U.S. Department of Energy
Office of Fissile Materials Disposition
P.O. Box 23786
Washington, D.C. 20026-3786

RE: Personal comments on "Programmatic Environmental Impact Statement
on Storage and Disposition of Weapons Usable Fissile Materials."

Figure S-3. Surplus Fissile Material Disposition Alternatives.

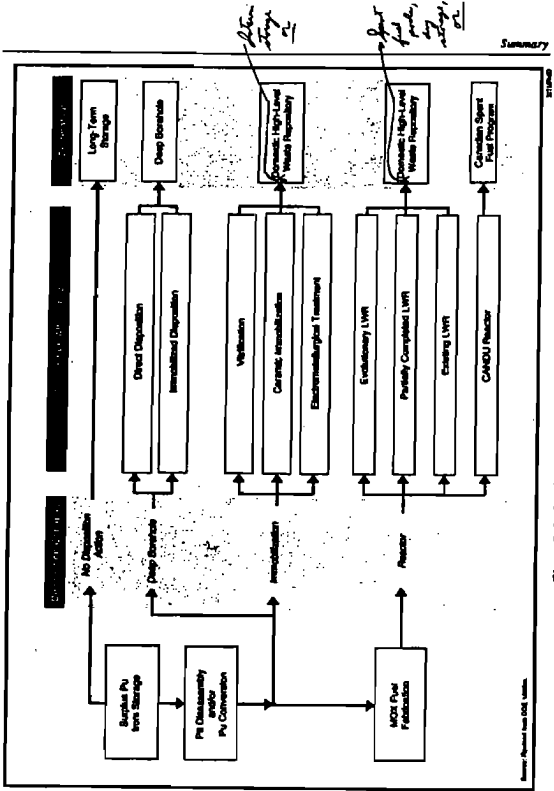
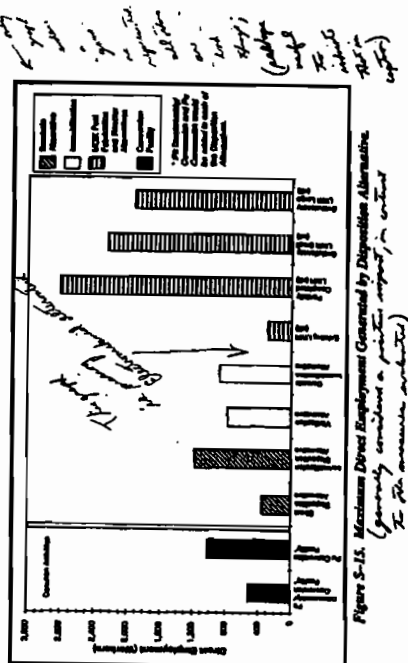
Development of Disposition Alternatives
For disposition, DOE began with 37 potential action alternatives (see Figure 5-3), as well as the No Action Alternative. Using the same criteria as for long-term storage, DOE identified 11 reasonable alternatives for surplus Pu disposition: (1) deep borehole (immobilization), (2) deep borehole (direct emplacement), (3) immobilization in glass immobilization, (4) ceramic immobilization, (5) electrometallurgical treatment, (6) immobilization in glass immobilization, (7) Eurochem mixed oxide (MOX) fuel fabrication, (8) immobilization in light water reactors (LWRs), (9) partially completed LWRs, (10) evolutionary or advanced LWRs, and (11) Canadian Deuterium Uranium (CANDU) reactors. Upon further study of supply/demand conditions for Eurochem MOX fuel and due to lack of maturity of the technologies for boronized glass immobilization, DOE deleted alternatives (6) and (7). However, MOX fuel fabrication (not just reactor burning) at Eurochem
